Groundwater Transfer Review Summary Form

Transfer/PA # T- 13439 (Temp)

Application: T-13439 (temp)

Applicant Name: Heyerly Brothers

Well Location Map

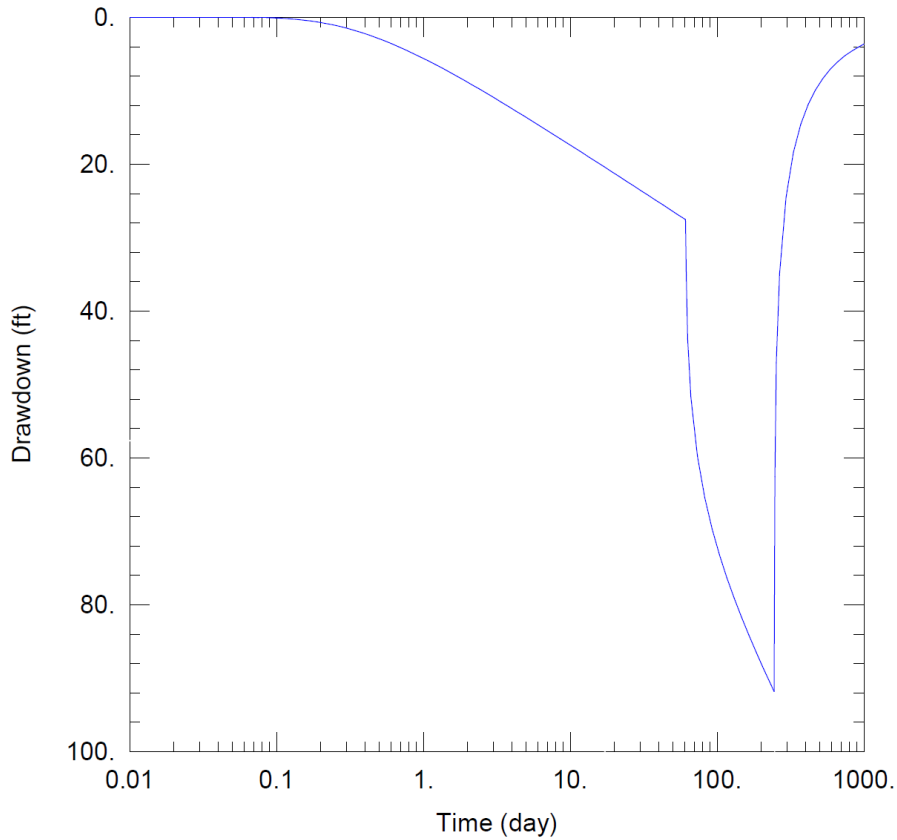
4. a) Will this proposed change, at its maximum allowed rate of use, likely result in an increase in interference with **another ground water right**?
 Yes No Comments: Compared to the currently authorized From-POA, both of the proposed To-POA will be substantially closer to **CLAC 66134**, an authorized POA under **Certificate 92166*** and **Permits G-15254*** and **G-18008***. The closer proximity of the proposed To-POA will likely lead to an increase in interference with **CLAC 66134**.

5. a) Will this proposed change, at its maximum allowed rate of use, likely result in an increase in interference with **another surface water source**?
 Yes No Comments: The proposed To-POA are substantially closer to several streams, including Bear Creek and Kaiser Creek. The closer proximity of the proposed To-POA is likely to increase interference with these surface water sources.
